TECHNICAL NOTE

Project name **Wrexham AFC - KOP Development**
Description: **Response to Flood Light Planning Queries**
Project no. **1620012485**
Client **Wrexham Association Football Club**

This technical note has been prepared in response to queries raised by the Planning Officer regarding the Flood Light Report, submitted as part of the planning application for the new flood lights. The purpose of the note is to formally capture the design team's response.

Appendix 4

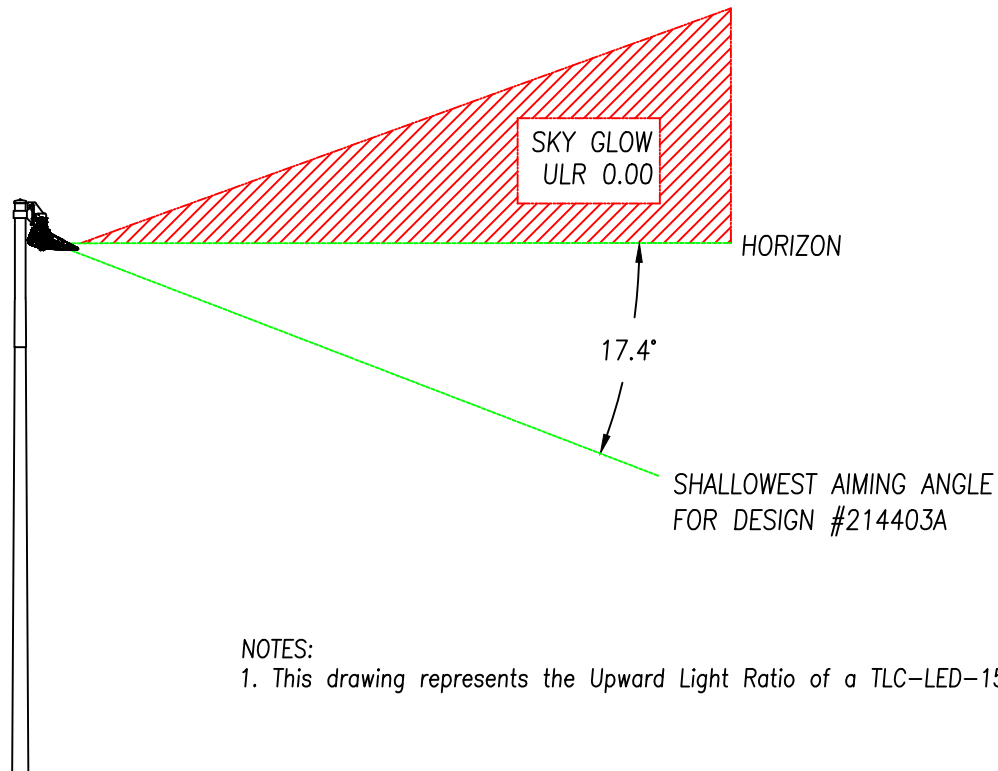
"There has been no discussion in the report on mitigation from light spill."

ULR Drawings (Appendix 4) indicate that with the use of the visored TLC 1500 luminaire there will be 0.0% skyglow or upward light resulting directly from the flood lights. This will be a key point for the planners, as the current lights have very little upward light control, so they throw significant light into the night sky.
